PP-  
95-64

## MAJOR SUBDIVISION: PRELIMINARY Resub.

# LOS ALTOS SUBDIVISION

TITLE HEADING: Preliminary Plan - Los Altos  
Subdivision

MAP B

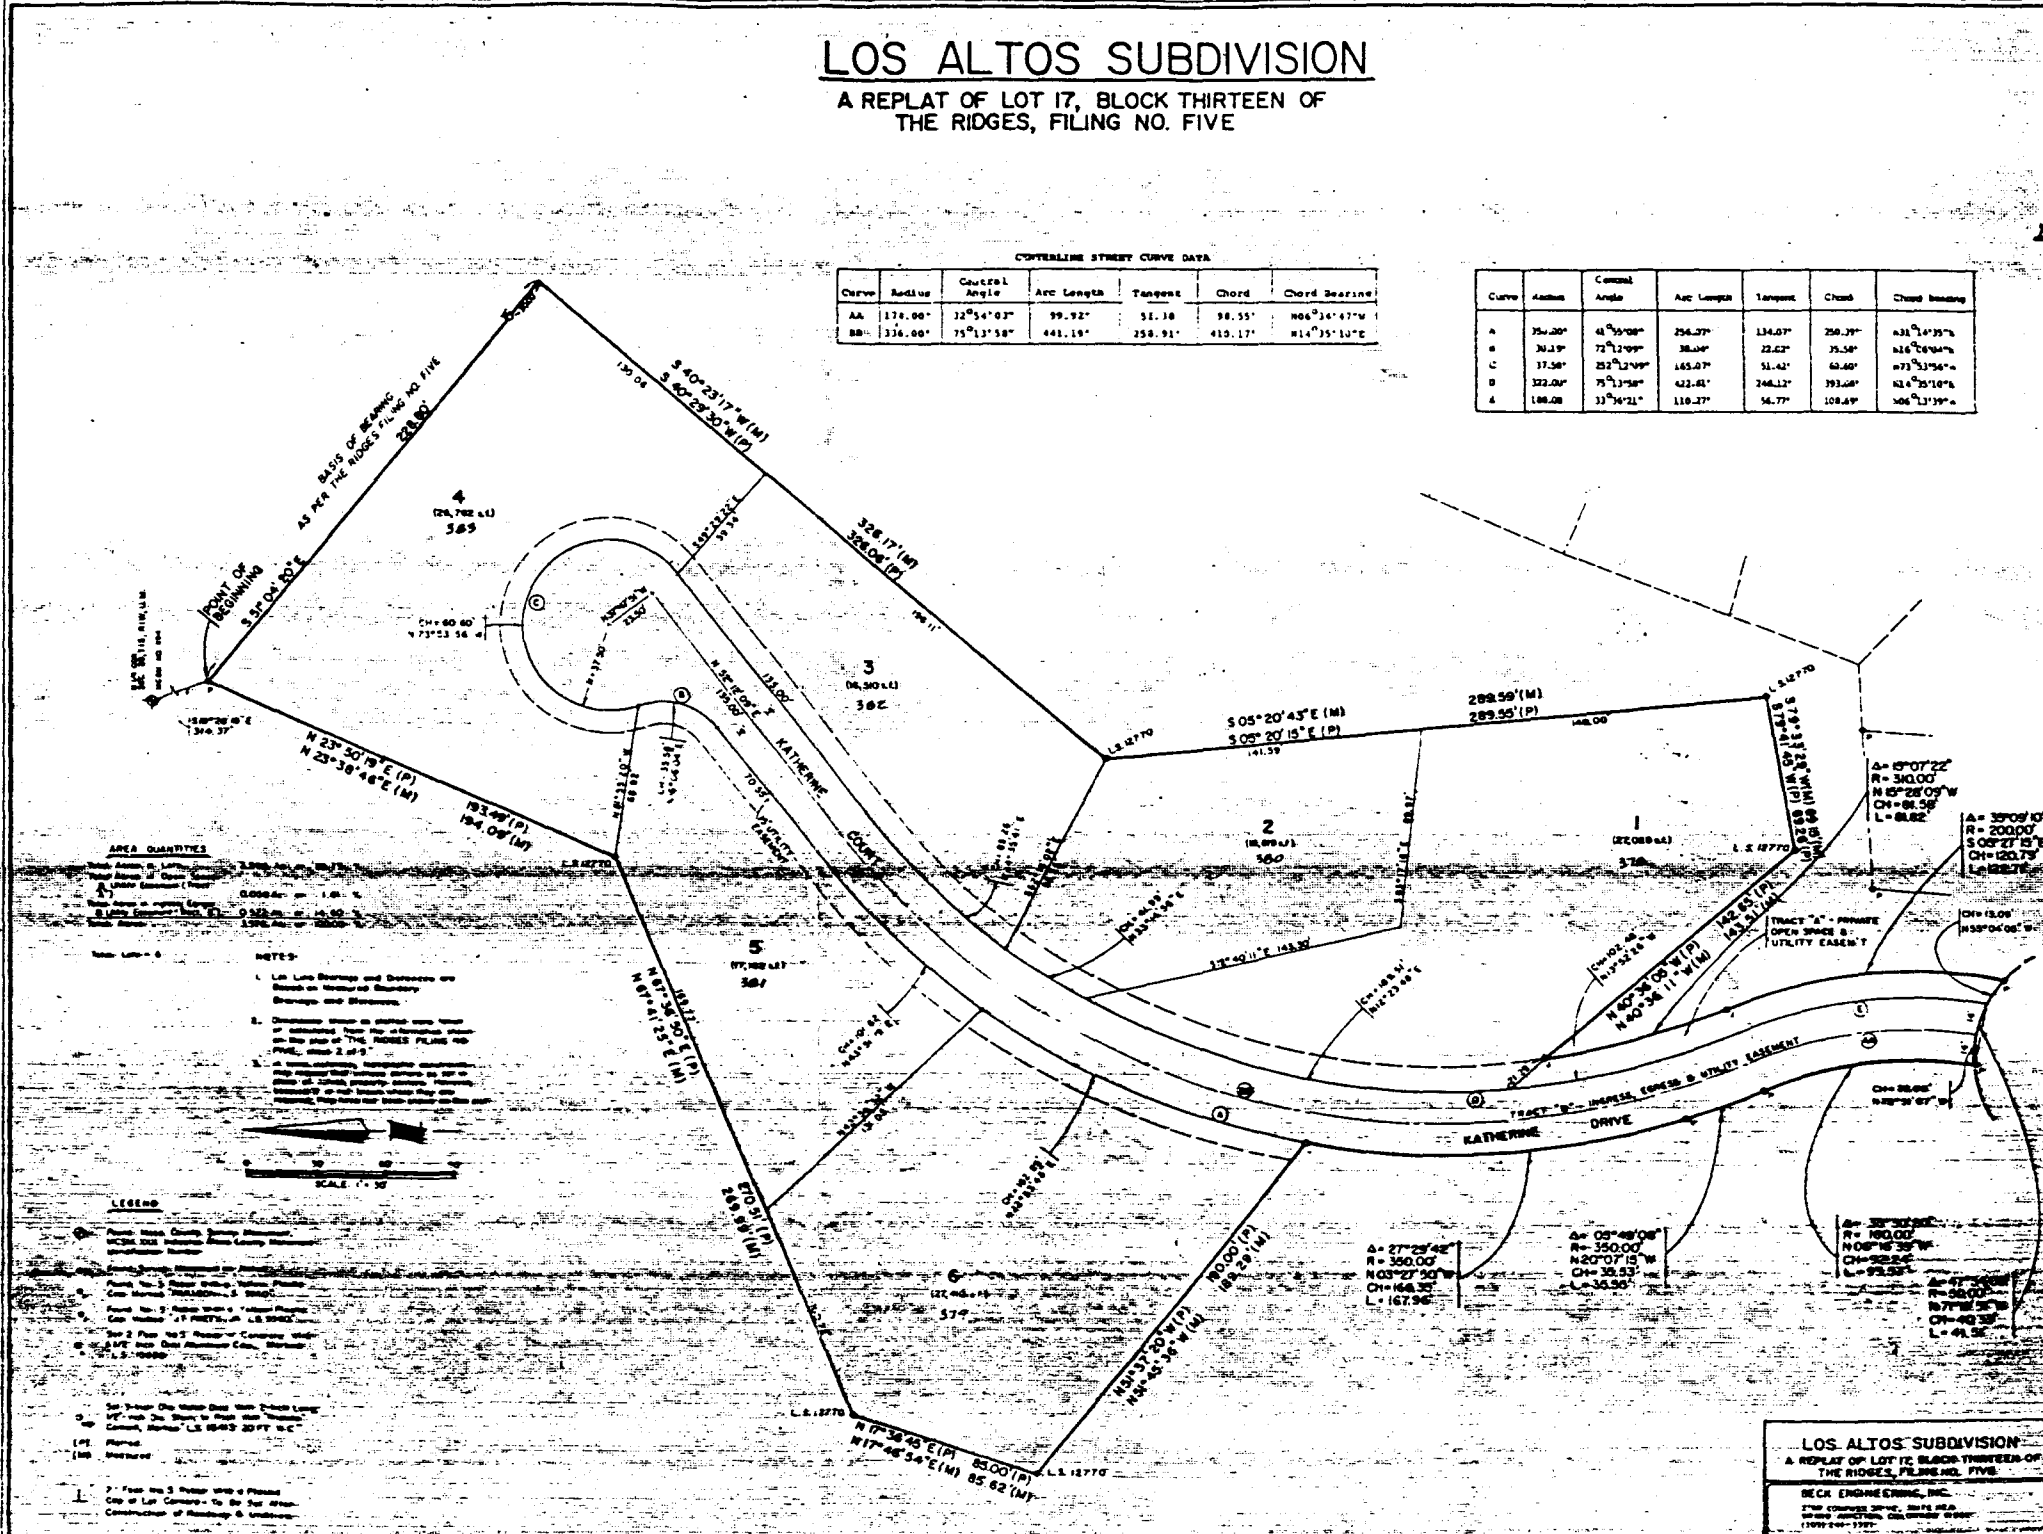
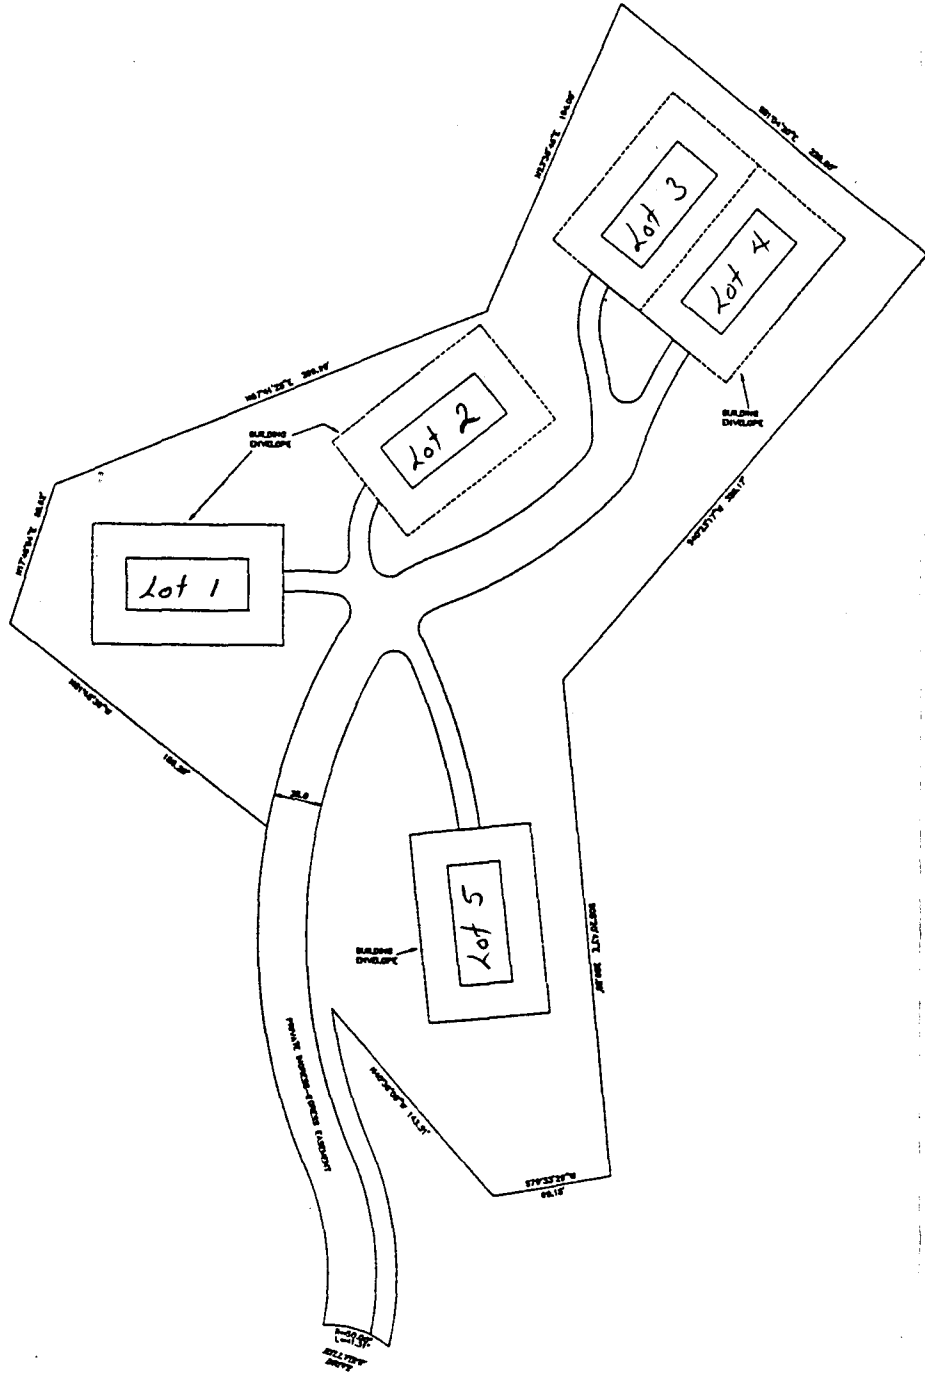
The petitioner needs to show on a drawing how the City Street Standard would look on the site and demonstrate the grades and width will be detrimental. If this is approved as a private road, a Homeowner's Association must be established and maintenance of the road is clearly established as the responsibility of the HOA.

Please clarify how the lots will be platted - which areas are to be designated as common open space.

Perimeter boundaries. See Map B

Proposed lots, Row. See Map B

Ownership. A Home Owner's Association will own the common ground within the 3.58 acre tract. Individual home owner's will own individual house lots. See Map B {Proposed lots}

Number lots. Lots are numbered 1 thru 5. (Map B)

Dimensions. Map B

Clarification of Lots. (Map B)  
Los Alto encompasses 3.58 acres  
Lots numbered 1 thru 5 cover 33% of area  
Private driveway cover 15% " "  
Open Space cover 52% " "

File # PP-95-64 MAP C

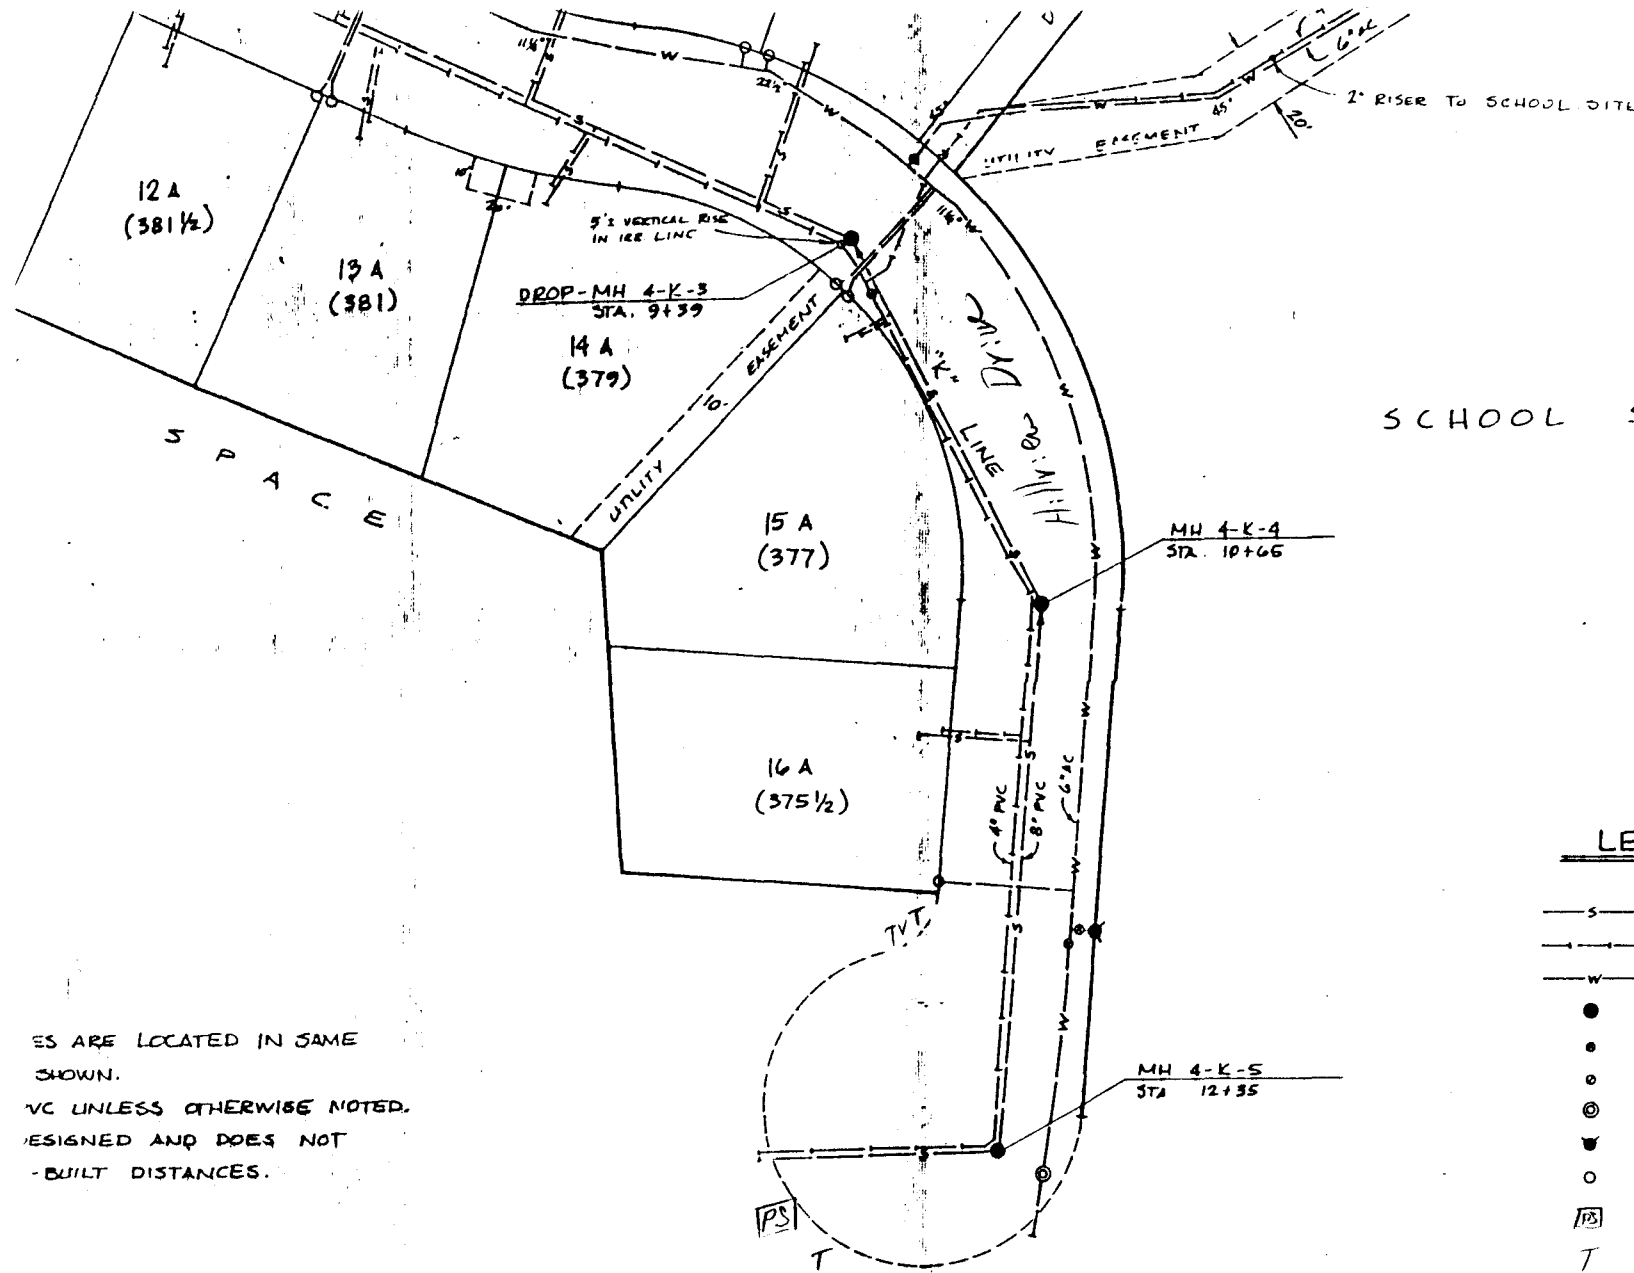
1. Submit a utility composite, including an area water map, showing locations of nearest looped water mains. Minimum water line size is 6" and cannot exceed 1,000' in length to nearest looped main. The proposed hydrant should be located in level area and such that all lots are within 250'.
2. Minimum fire flow requirements of 500 gallons per minute must be provided. Contact the Fire Department to schedule a time to flow test area hydrants to determine available flows.
3. If the proposed private drive exceeds 150' in length, adequate turnarounds are requested for Fire Department apparatus. Current City standards for public streets call for a cul-de-sac of at least 40' radius.

There is not enough information to provide an adequate review. Information provided is inadequate for even a preliminary review since the applicant is proposing water and sewer line installations.

Proposed water, sewer, irrigation. Map C

Existing (ends at Hillview Dr)

water 6"line

sewer 8"line

irrigation 4"

Proposed

6"line 525'

6"line 525'

none
